**PERSIMMON HOMES THAMES VALLEY
NORTH LITTLEHAMPTON
INTERNAL WORKS, PARCELS B2, B4 & C1
LITTLEHAMPTON, WEST SUSSEX**

**STAGE 1 - ROAD SAFETY AUDIT
ADDENDUM**

SEPTEMBER 2017

GENERAL ARRANGMENT DRAWING (2 OF 2)

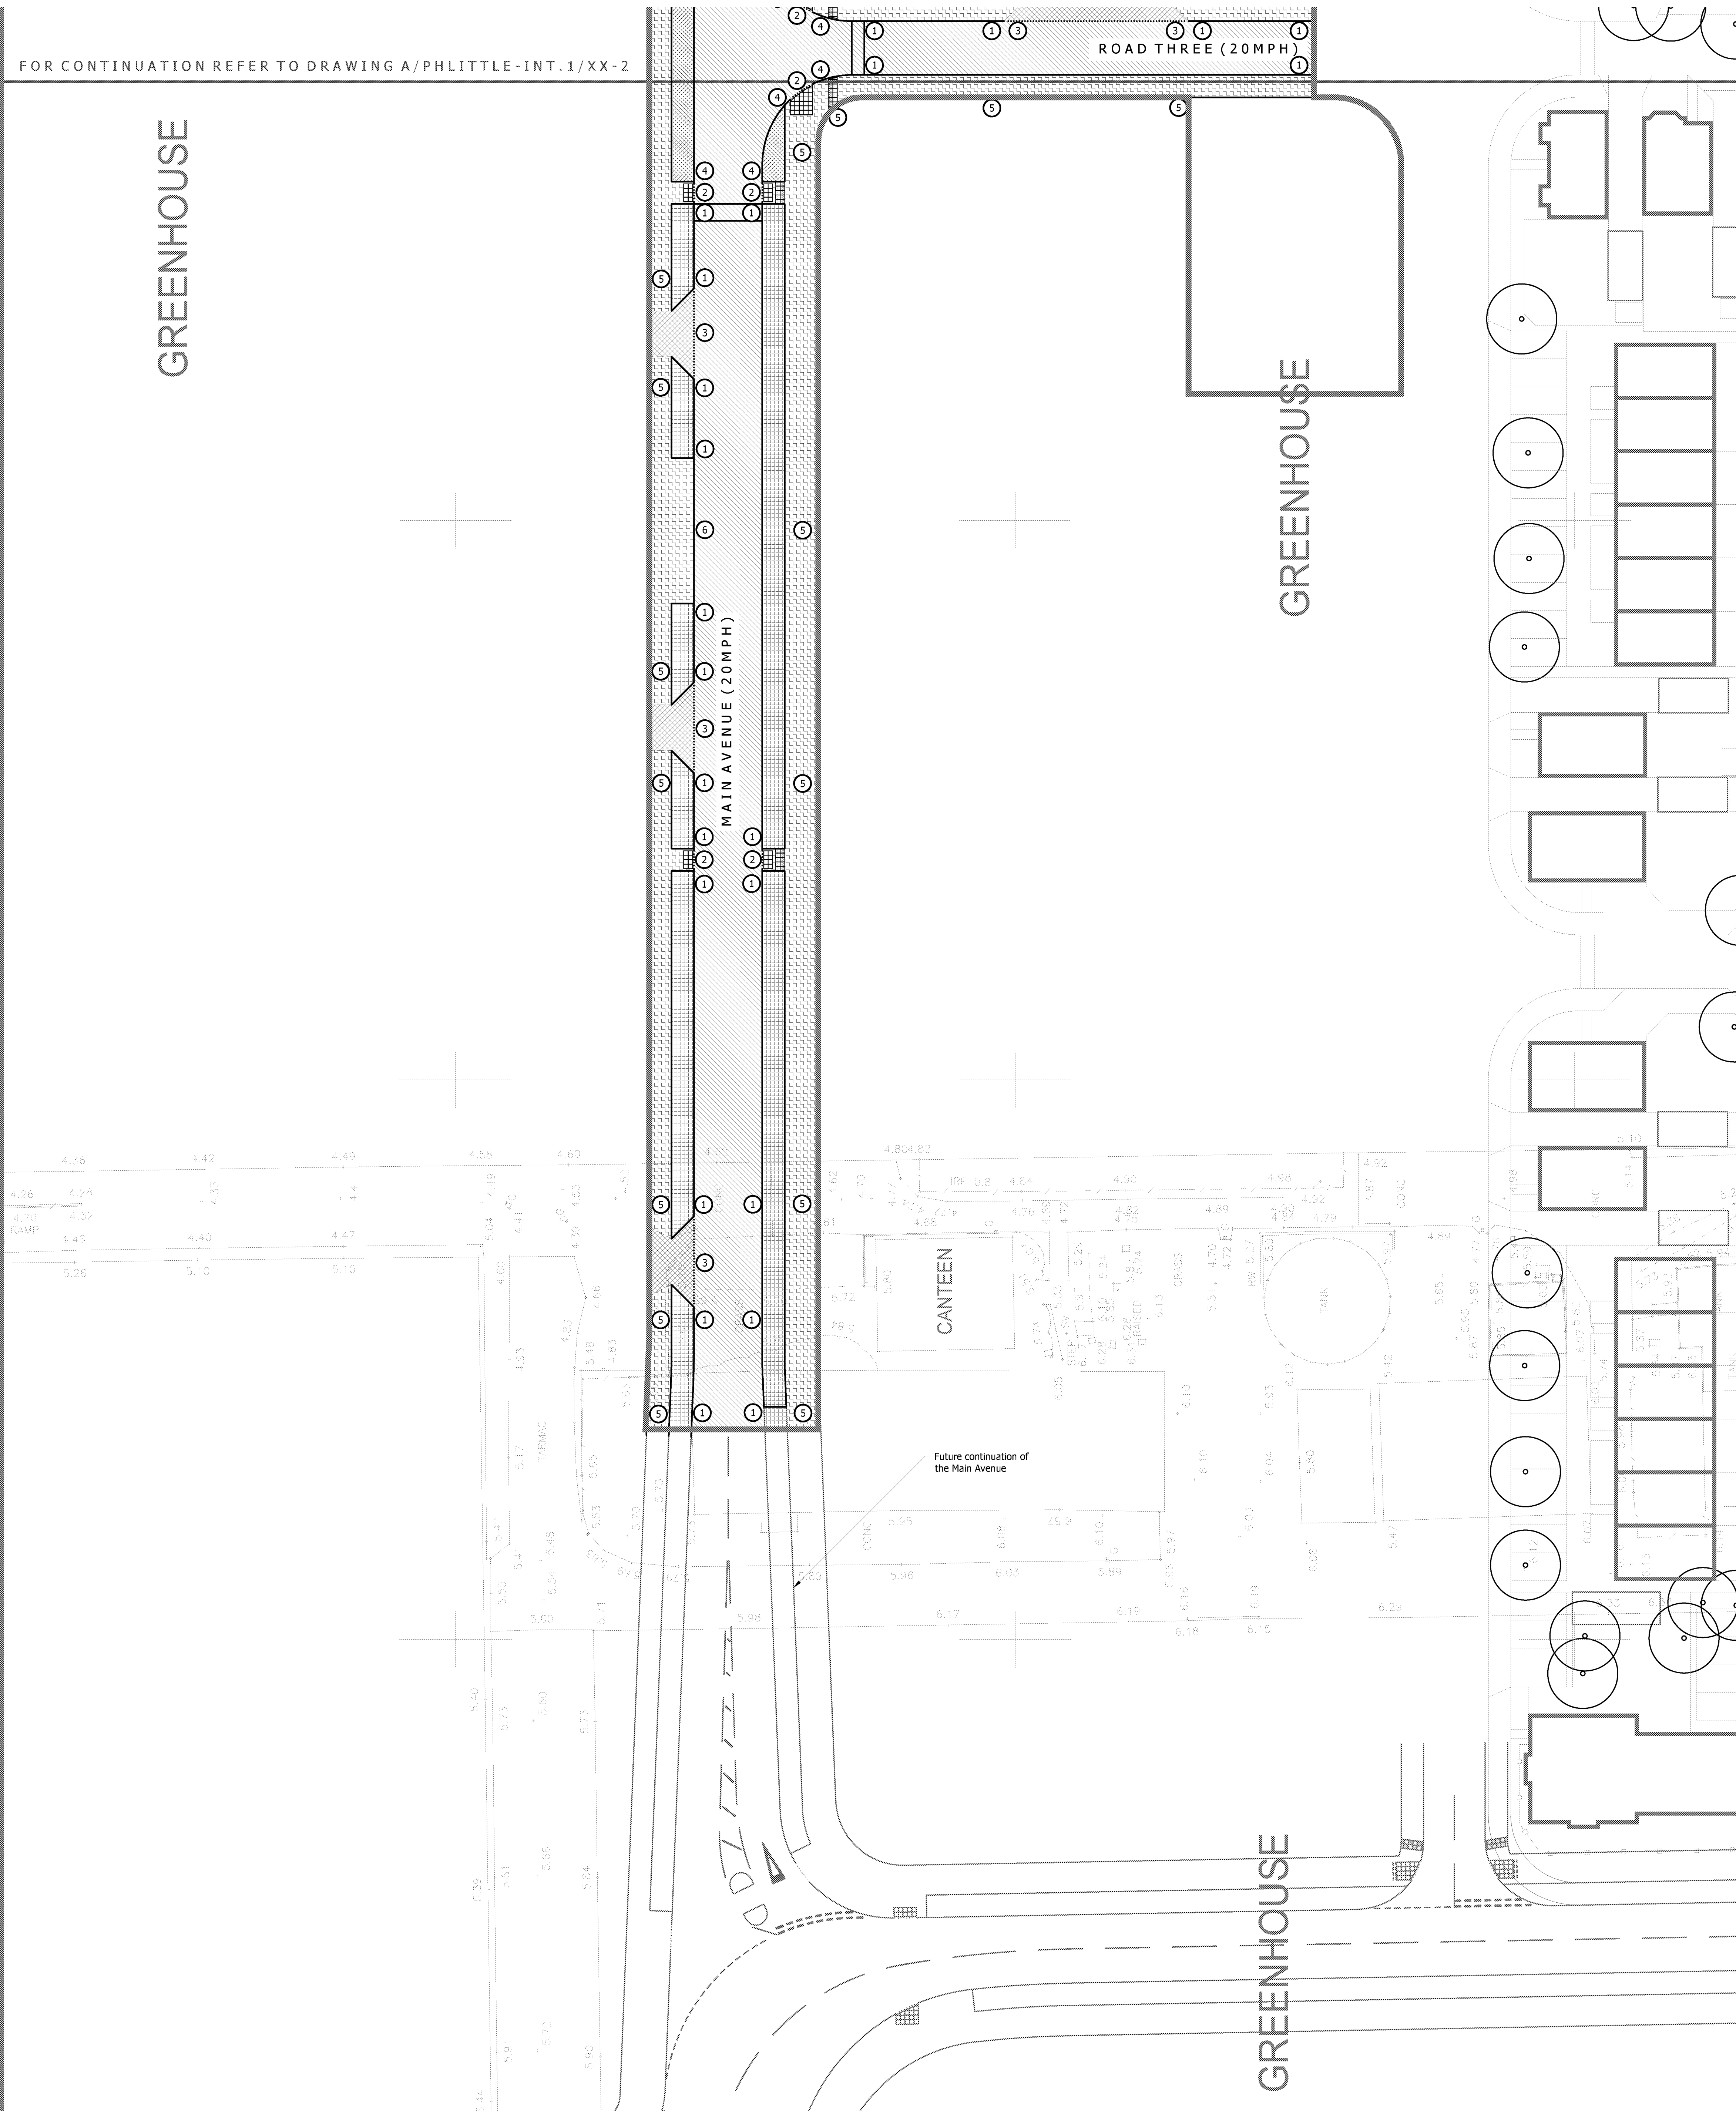
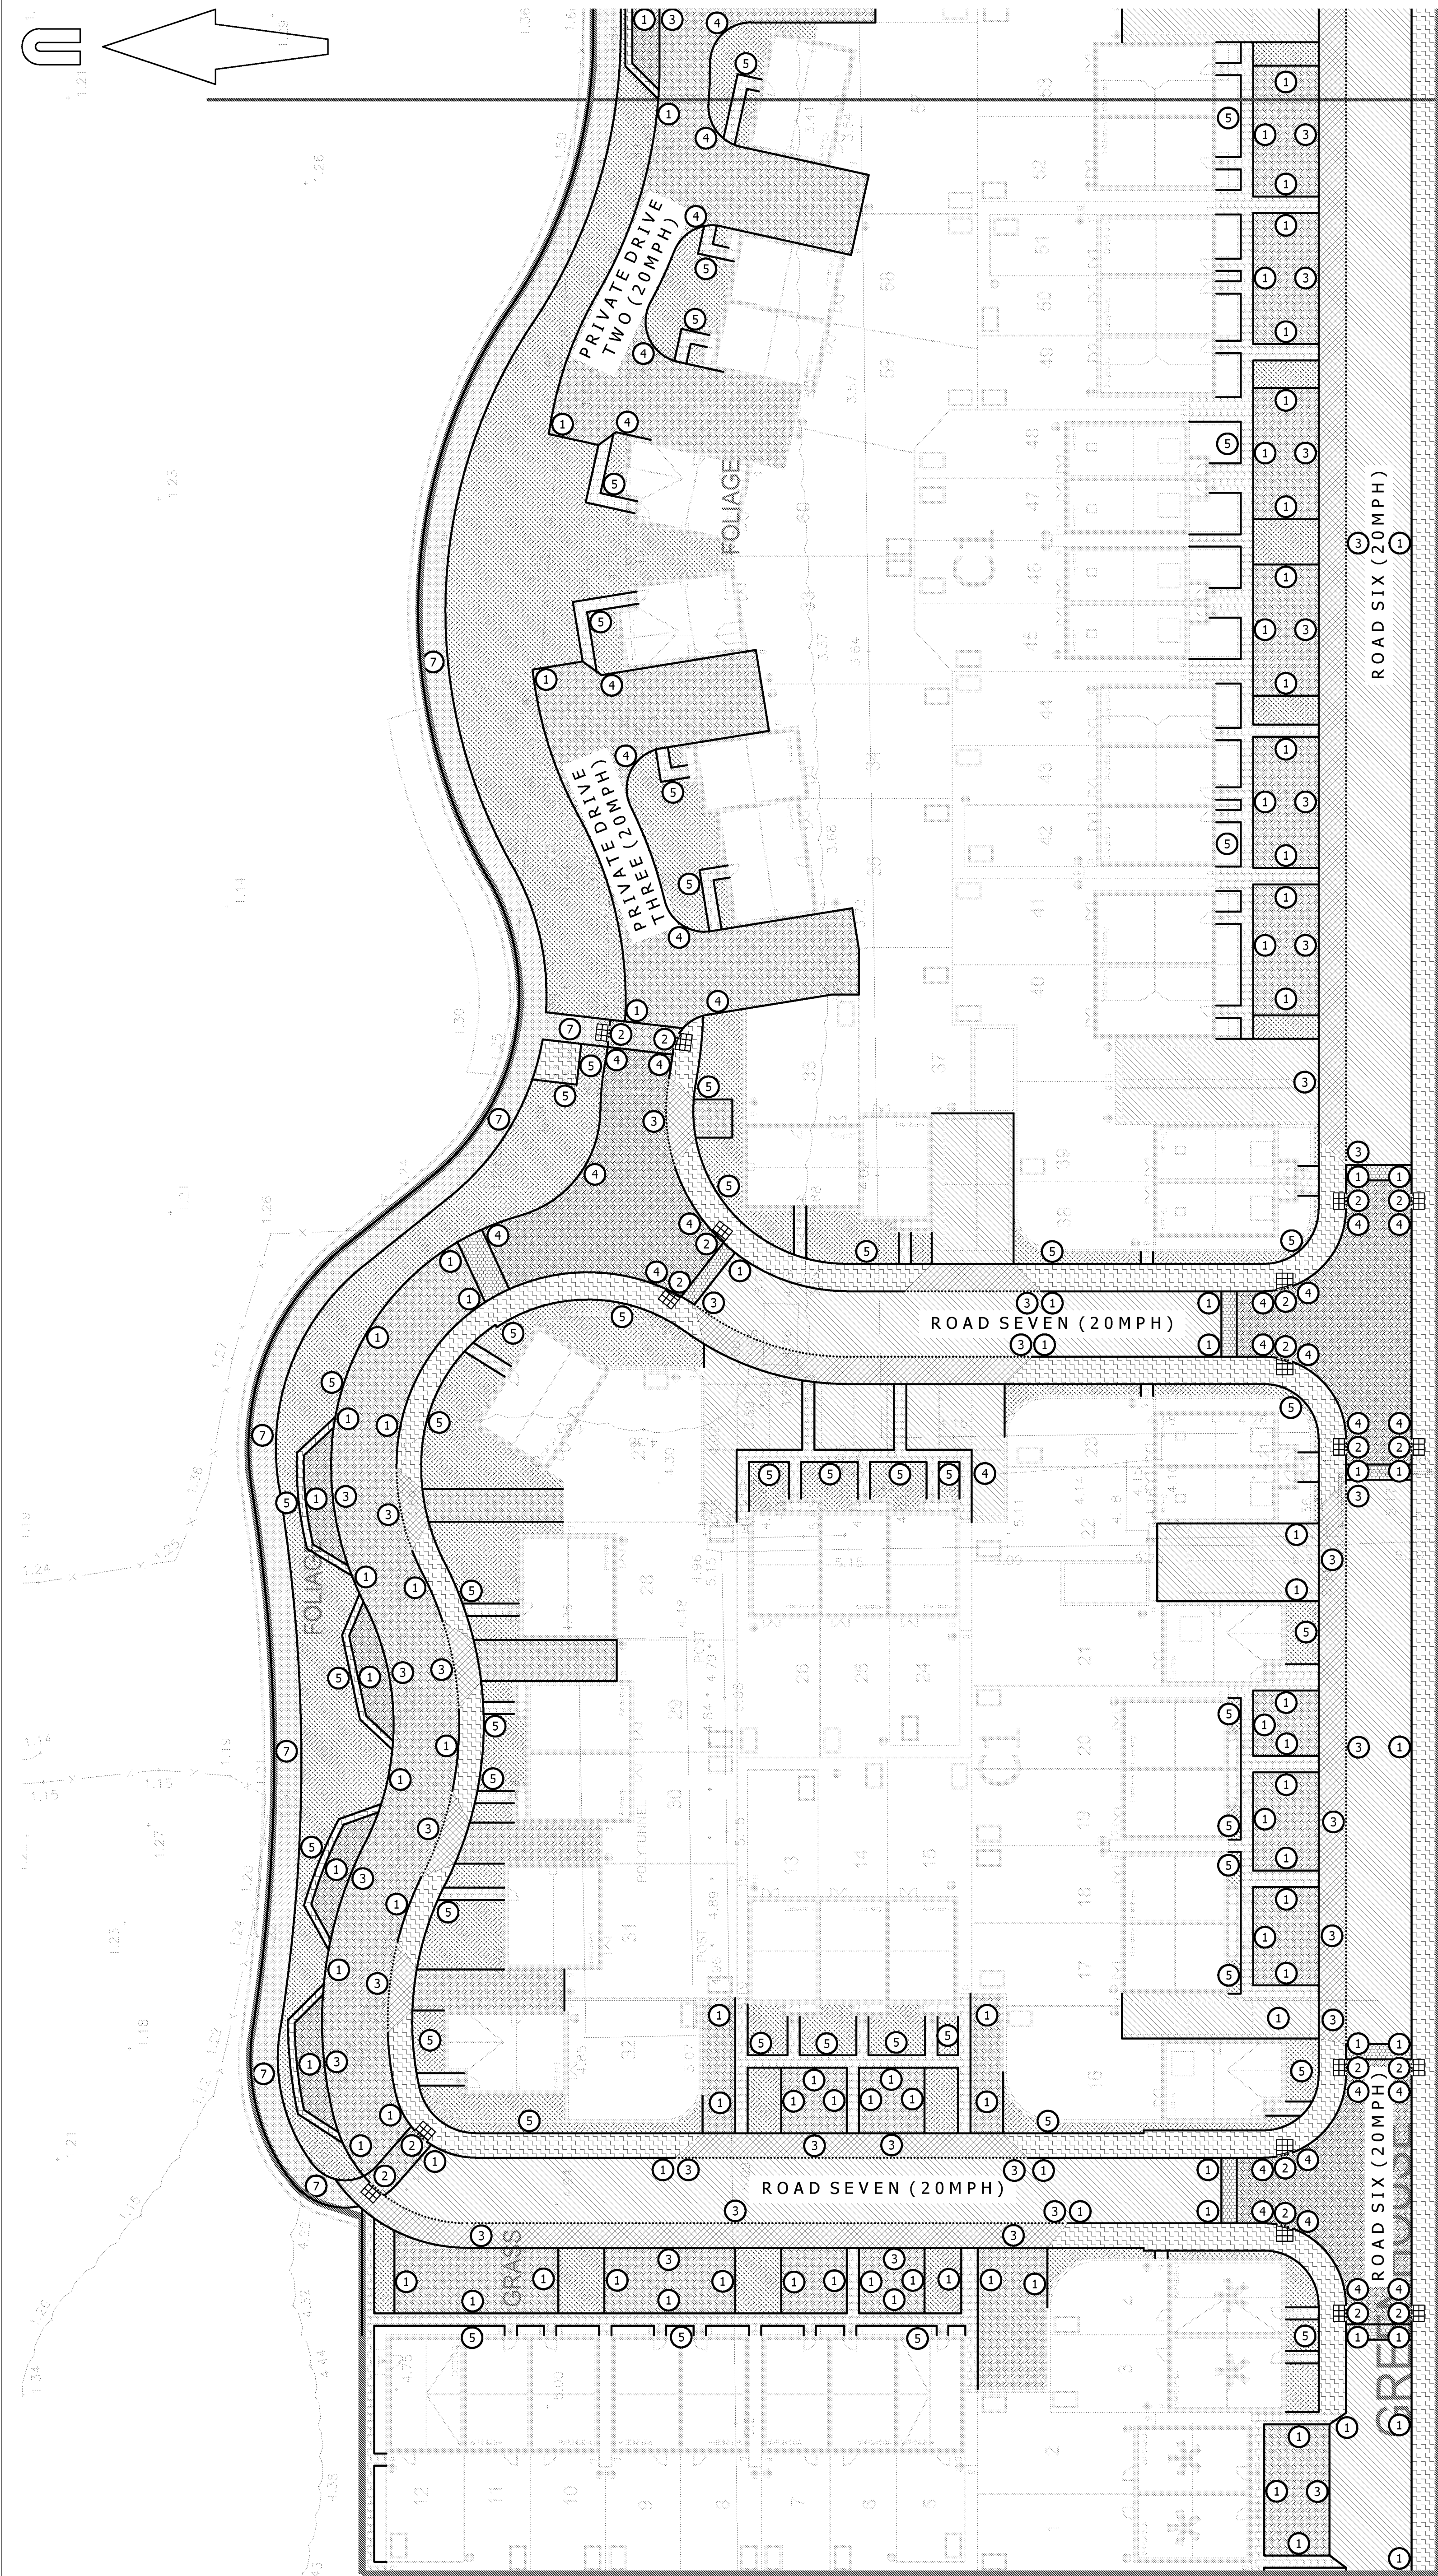
Summary: Visibility splays

Whilst some visibility splays have been formally identified on the drawings submitted, it will be important that all visibility splays remain free from obstruction. It is noted that some visibility splays extend across / through 3rd party land, cycle storage areas or parking bays (on 3rd party land).

It will also be important to ensure that appropriate visibility splays are provided. It is noted that the visibility splays indicated on parts of Main Avenue are not suitable for a 30mph speed limit.

Provide visibility splays in accordance with relevant design standards and ensure that the splays will be kept free from obstruction. Any vegetation within the splays should be maintained to ensure that it does not extend beyond a vertical height of 0.6m. If planters are to be provided then these, together with any foliage which they contain, should also not extend beyond a vertical height of 0.6m.

title
ANTICIPATED SWEEP PATH OF A LARGE REFUSE VEHICLE & LARGE CAR ACCESSING THE SITE (1 of 2)

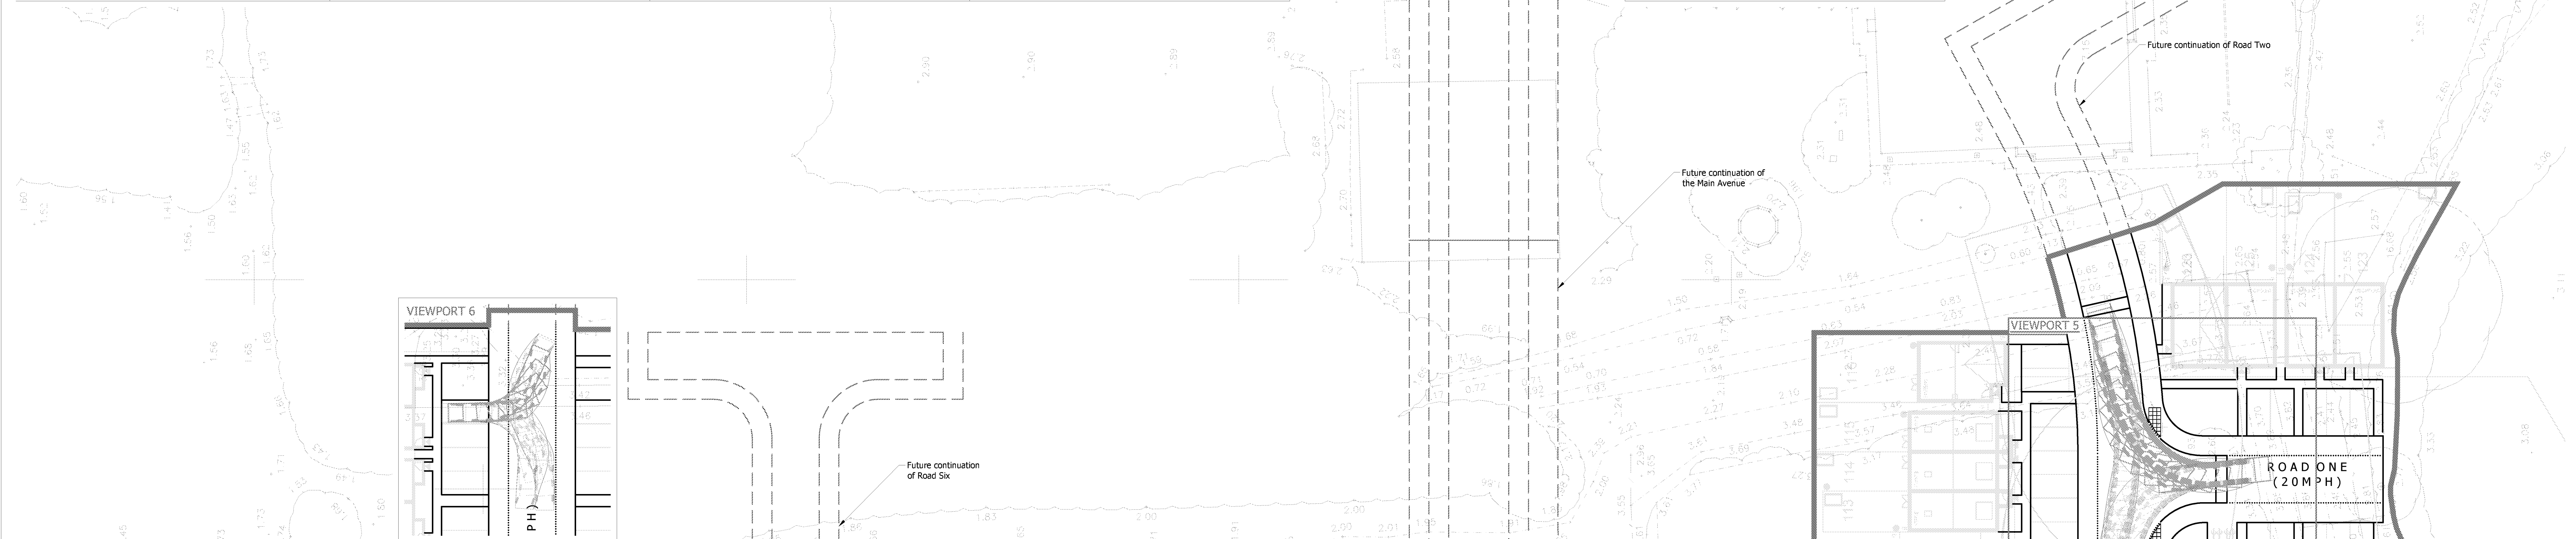
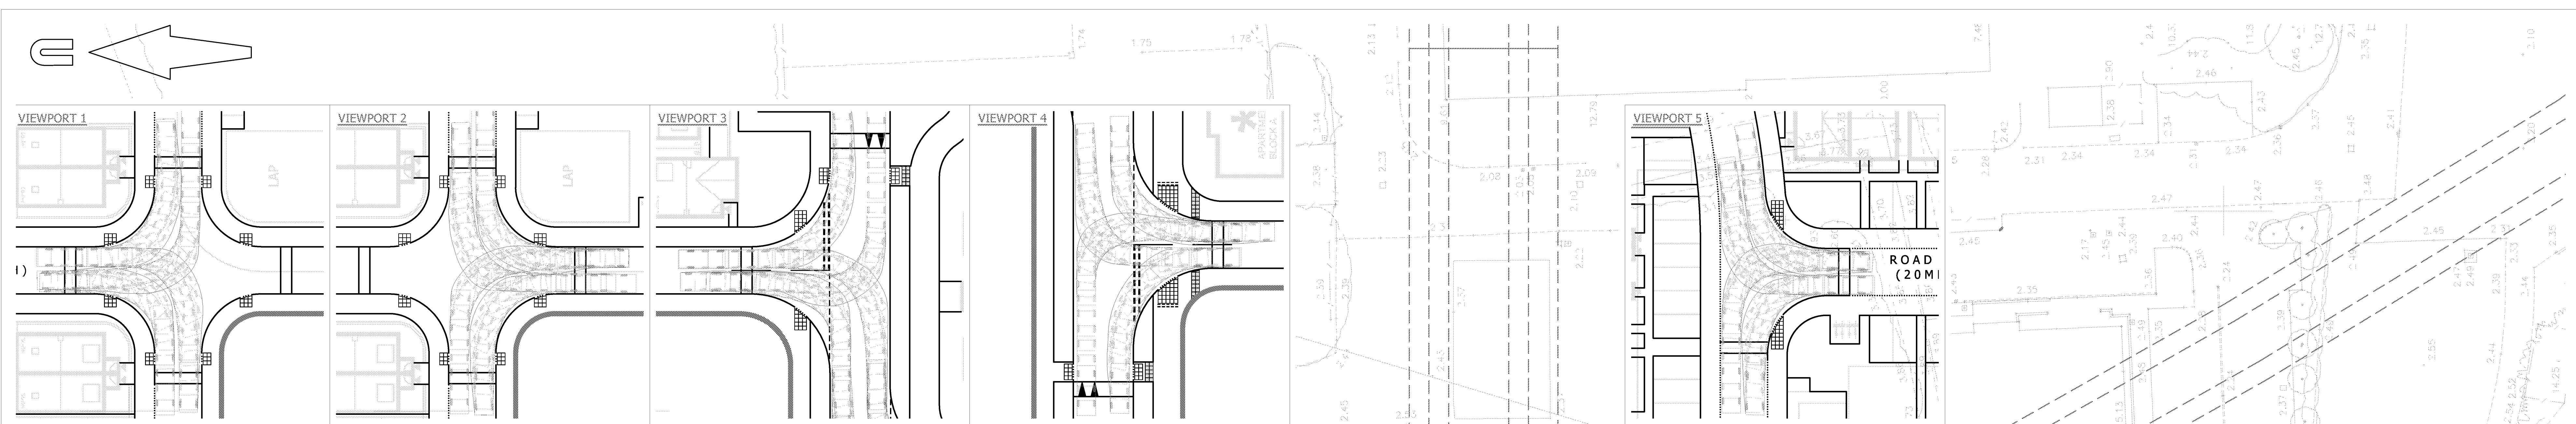
Summary: Potential obstruction to service vehicle manoeuvres

The swept path analysis provided to the Audit Team indicates that a large refuse vehicle is able to service the site without excessive reversing manoeuvres or encroachment on the footway.

However, many of these manoeuvres will be obstructed if on-street parking were to occur within the development. This could result in excessive reversing manoeuvres or encroachment on to the footway(s).

If on-street parking does occur within the extent of the swept paths then West Sussex County Council should consider implementing a traffic management order prohibiting vehicles from waiting “at any time” within the extents of the swept paths.
